"Beef The Tube"
by W.H.

Original schematic "cut-out" below is of the Gemtronics GTX-5000. Other similar type may be "modified" the same way.

ORIGINAL - UNMODIFIED, LAYOUT:

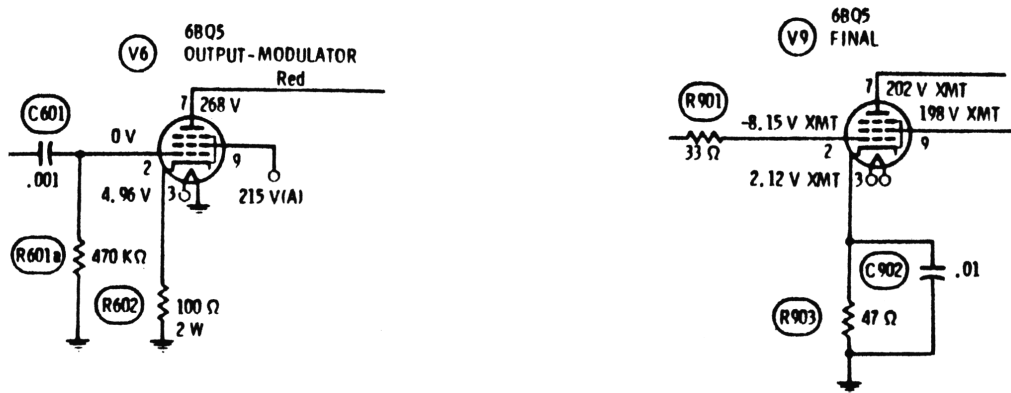
Most tube type units just don't have it in the audio department when it comes to output modulation swing in transmit.

By adding a few parts a vast improvement will be immediately noticed! **DO NOT REMOVE ANY ORIGINAL PARTS OR WIRING!**

"MODIFICATION" - Added Parts are shown only with the tube pin #'s....
